VILLAGE SQUARE ADDITION  
WICHITA, SEDGWICK COUNTY, KANSAS

Re: S/D97-75 -- Final Plat of VILLAGE SQUARE ADDITION

STAFF REPORT

CASE NUMBER: S/D 97-75 VILLAGE SQUARE ADDITION

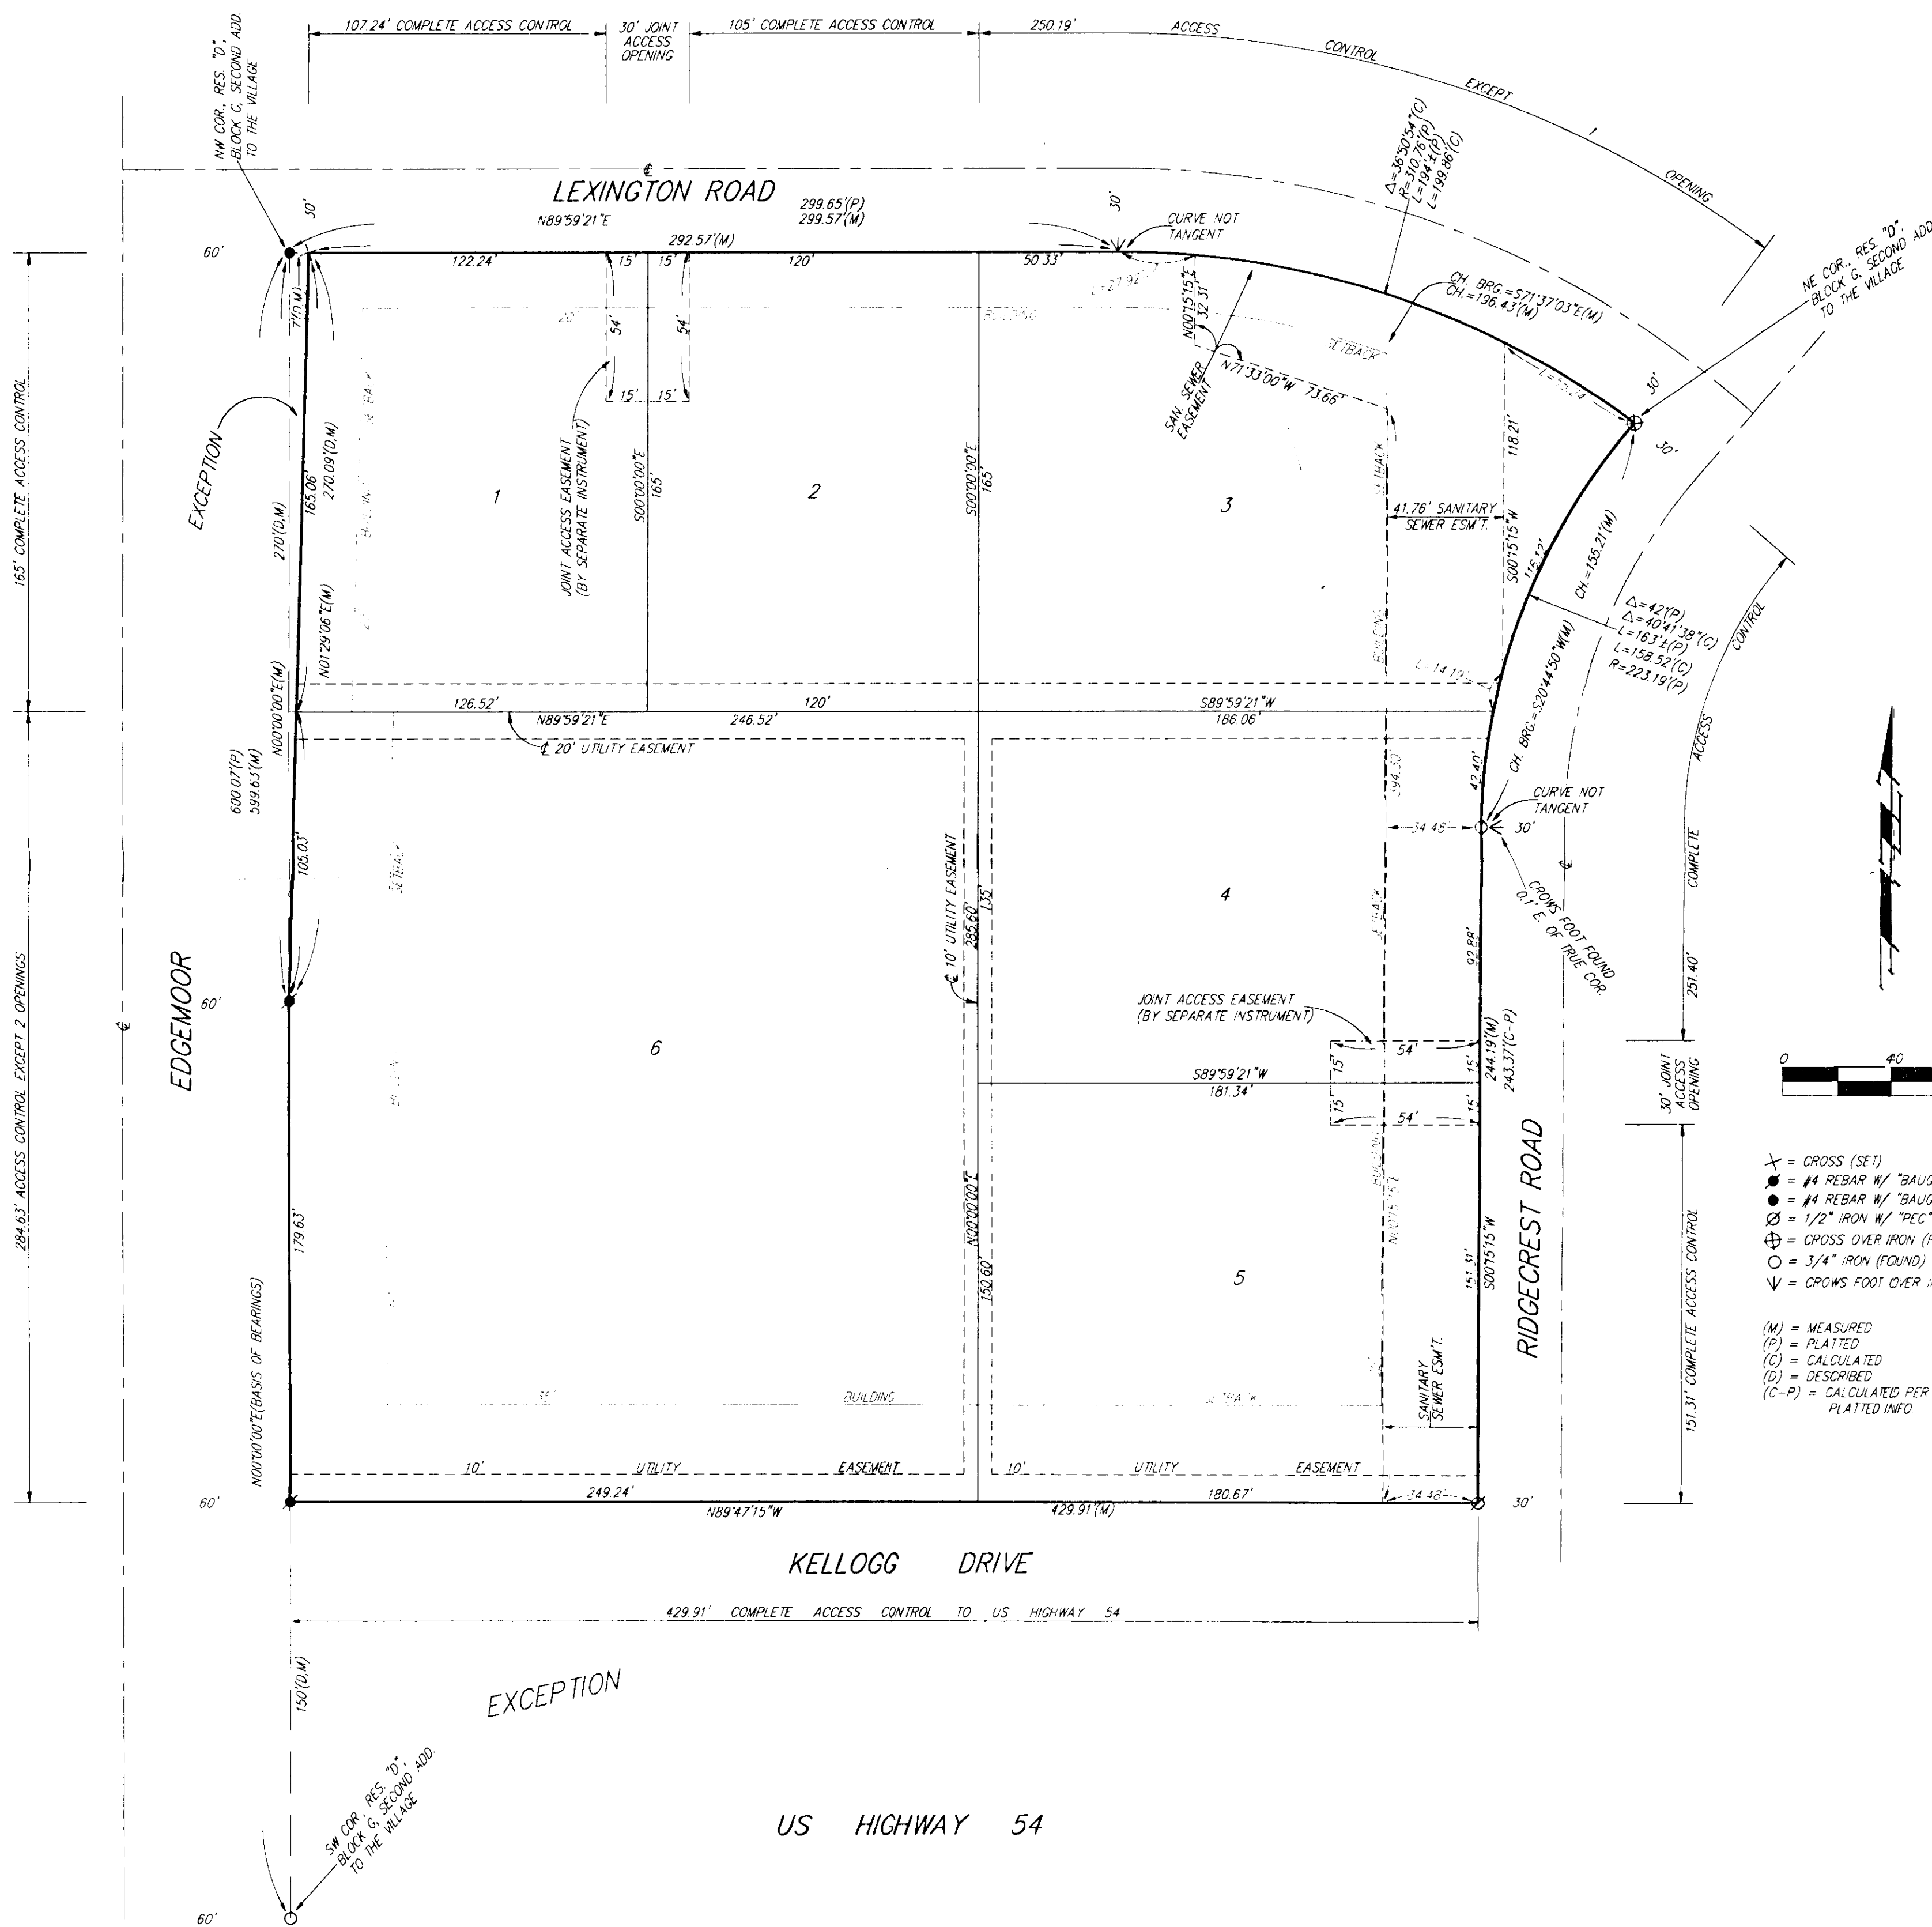
- A. It appears existing sewer and water service are available to the site. Engineering will need to comment on any guarantees or easements needed. City Engineering requests a sanitary sewer easement to coincide with the proposed location of the sewer. A temporary easement will be needed to cover the existing sanitary sewer lines which are to be abandoned (as denoted on the plat) unless abandonment of the lines will occur before the plat is recorded.  
A guarantee for extension of the water line to Lot 2 will be required.

- B. Engineering needs to comment on the status of the applicant's drainage plan. The drainage plan is acceptable to City Engineering.
- C. Traffic Engineering needs to comment on the acceptability of access controls. Distances should be shown for all segments of access control. On the final plat tracing, since the site is within the City limits of Wichita, the plat's text shall note that the access controls are being dedicated to the City of Wichita and that the location of the openings are subject to the approval of the City Engineer. The applicant shall guarantee the closure of any driveway openings being located in areas of complete access control or that exceed the number of allowed openings. Traffic Engineering has approved the following proposed access controls: two openings from lot 6 to Edgemoor, complete access control from Lot 1 to Edgemoor, two openings along Lexington Road, and one opening along Ridgecrest Road. Planning Staff has indicated the need for complete access control along Kellogg Street until the frontage road is constructed.

- E. The proposed joint access easements will need to be established by separate instrument. Initial construction responsibilities and future maintenance of the driveways within the easements should be addressed by the text of the instrument.

- L. The representatives from the utility companies should be prepared to comment on the need for any additional utility easements to be platted on this property. **The representative from KG&E has asked for additional easements, which have been incorporated on the final plat.**

- M. The final plat shall meet the requirements of Part 4, Article 5 of the MAPC Subdivision regulations.
- N. The applicant shall submit an avigational easement covering all of the subject plat and a restrictive covenant assuring that adequate construction methods will be used to minimize the effects of noise pollution in the habitable structures constructed on subject property.
